MODIFICATION #2
WEST LILAC ROAD OVER I-15 BRIDGE
DEPARTMENT OF PUBLIC WORKS

**Request for a
Modification to a Road Standard
and/or to Project Conditions**

Project Number: TM 5571/5572 Date of Request: January 31, 2014

ATTACHMENT 1

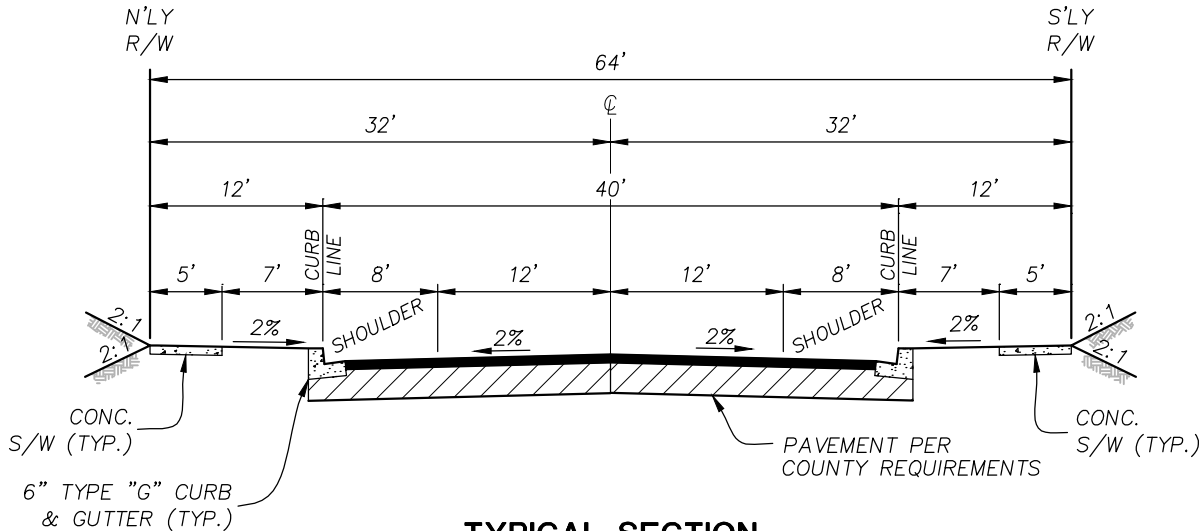
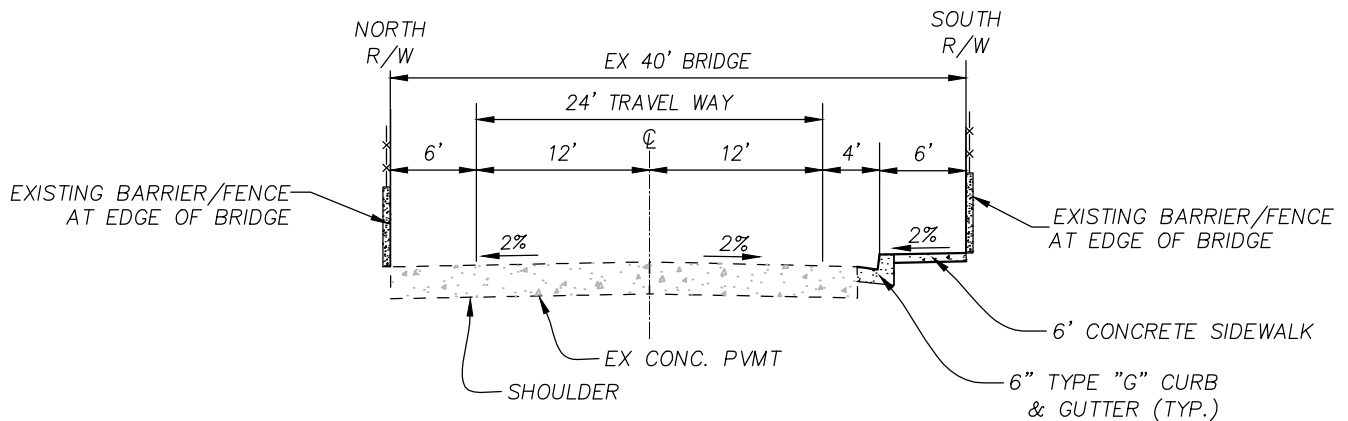
The standard road section for Light Collector Road 2.2C is 40'-54' wide curb to curb
width on 64'-78' r/w with a minimum design speed of 40 mph. The requested modification
to the road standard is to require no widening of the existing 40' wide West lilac Road
bridge over I-15 and allow only re-striping and the addition of curb, gutter and sidewalk
on one side of the road (see attachment 1).

ATTACHMENT 2
LILAC HILLS RANCH: LIGHT COLLECTOR 2.2C
MODIFICATION TO ROAD STANDARDS

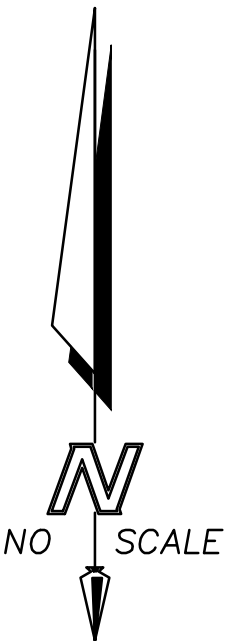
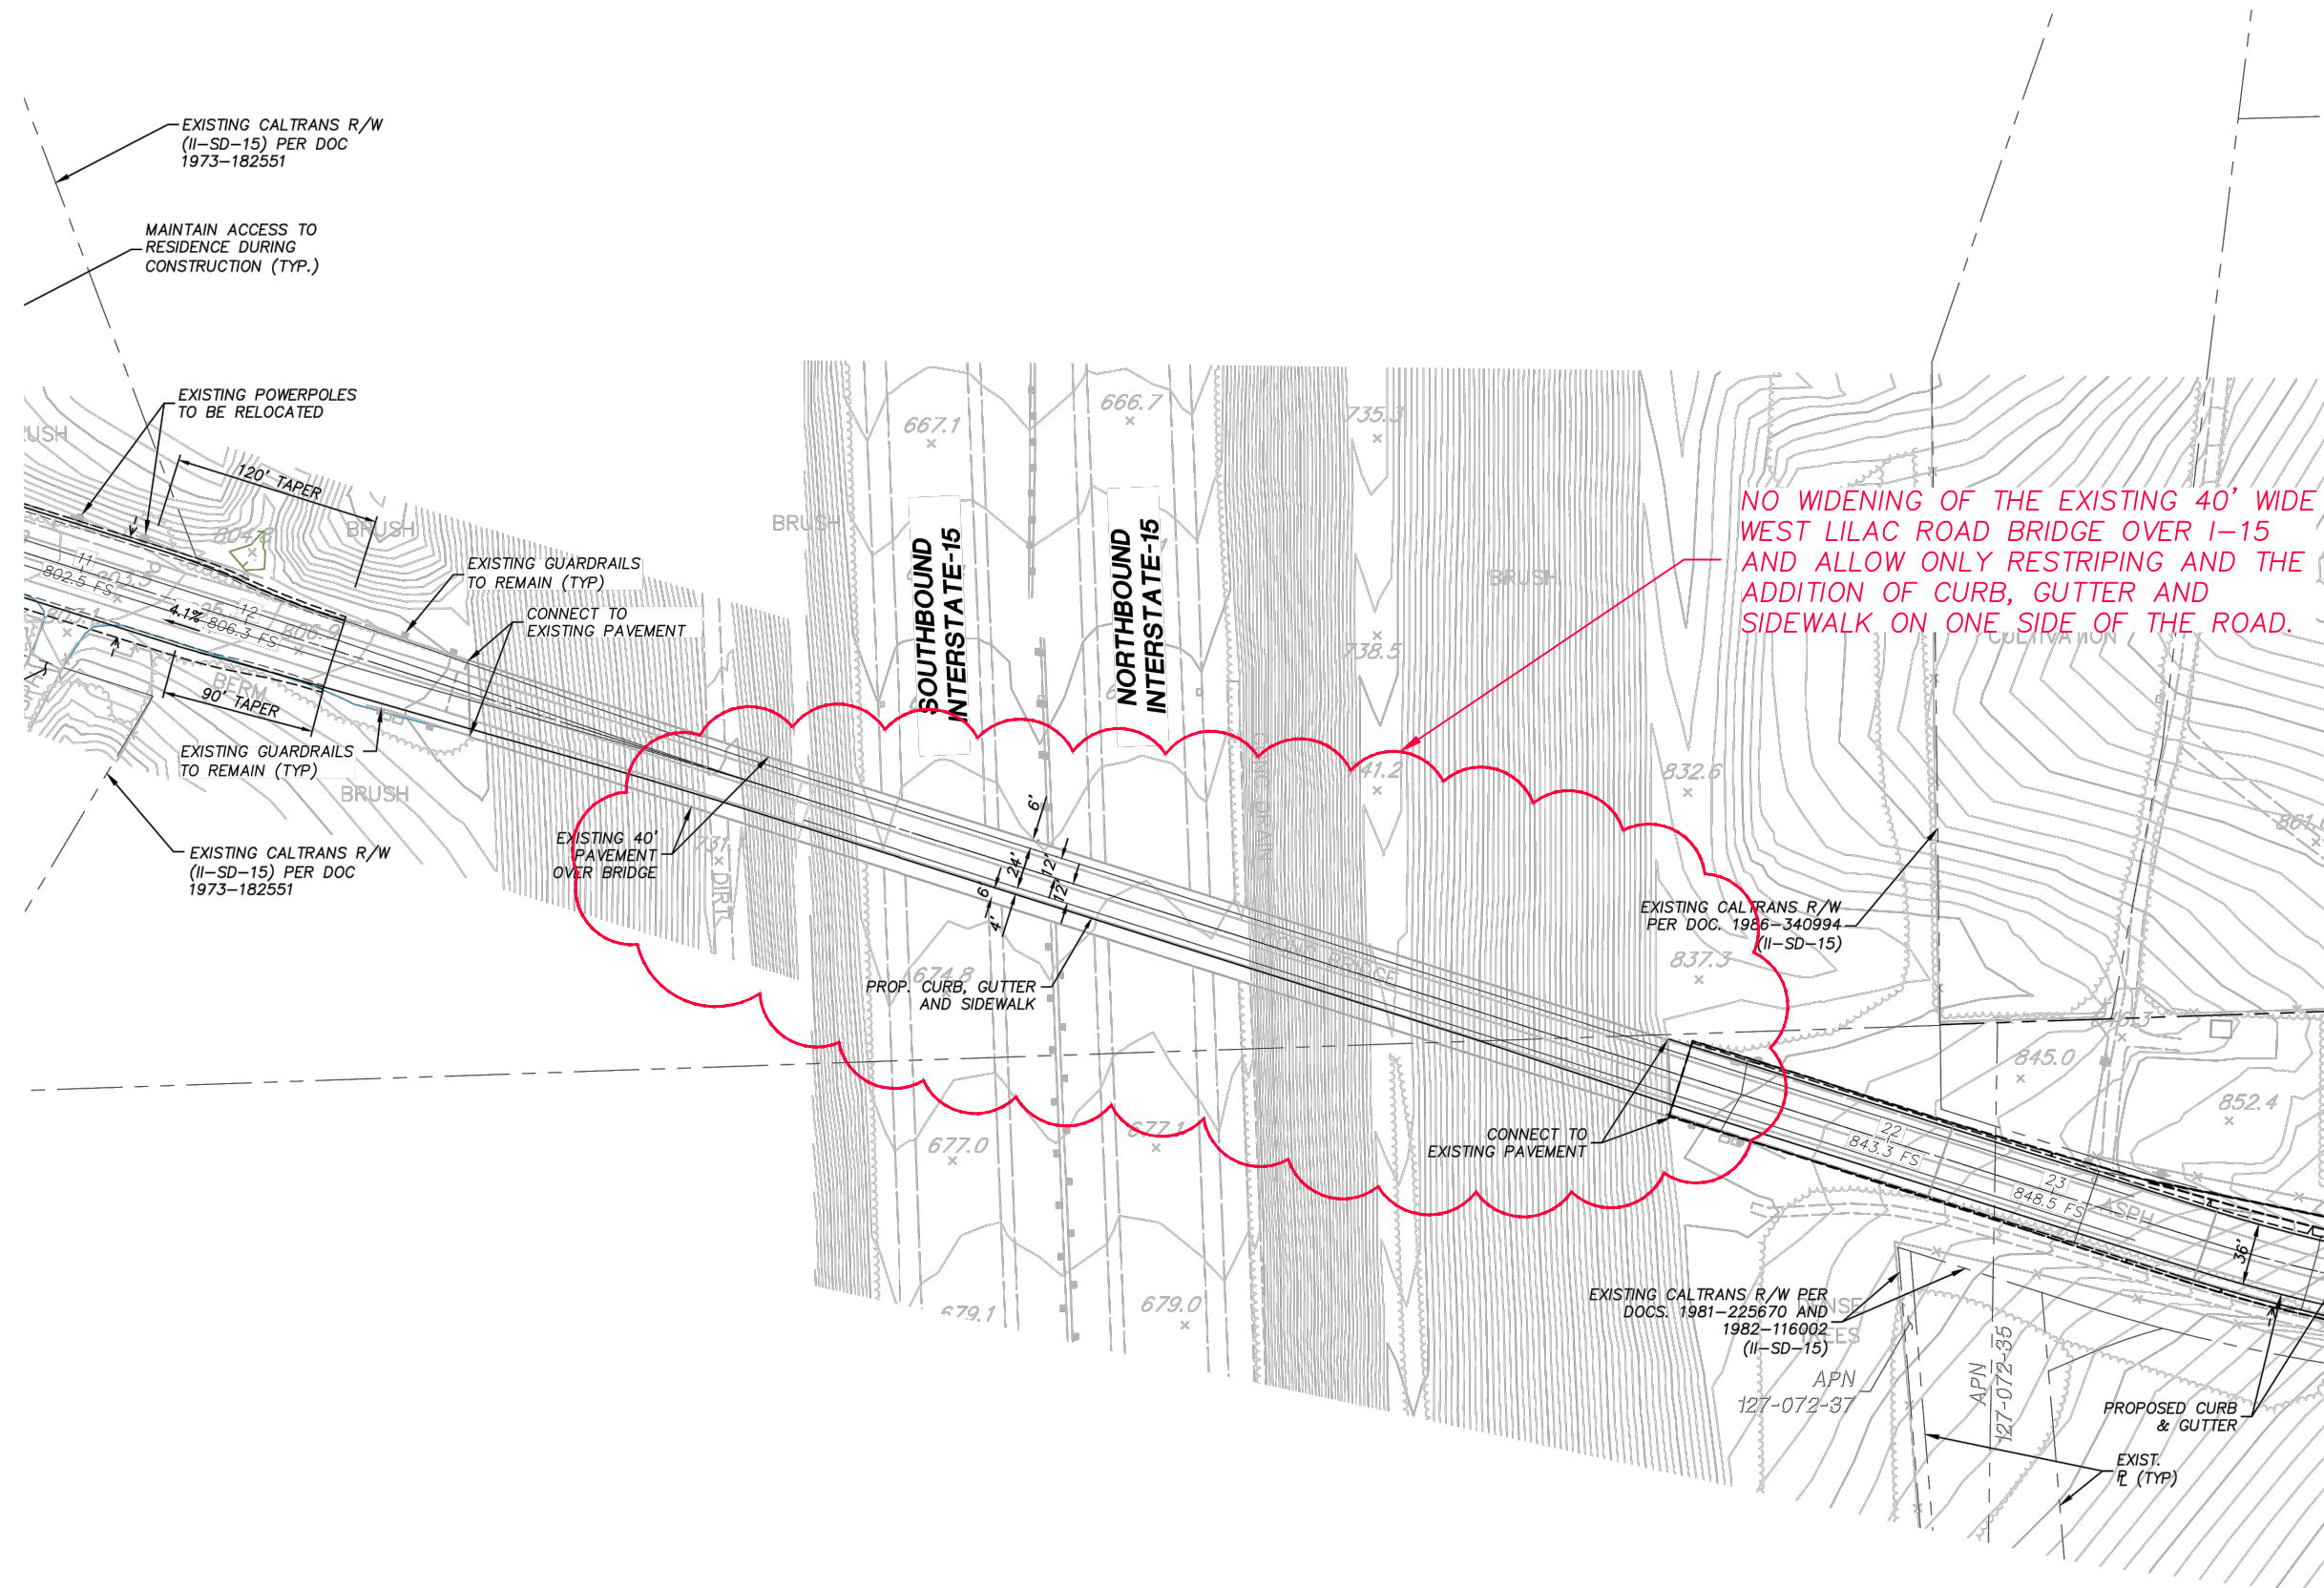
The existing 40' wide bridge section has a 24' travel way with 8' shoulders on each
side. A proposed widening of the bridge would be extremely expensive, extremely
disruptive to anyone that uses West Lilac Road & I-15, and would alter the beauty and
historic nature of the bridge (see attachment 2). The modified road would also allow
for safer pedestrian traffic over the bridge.
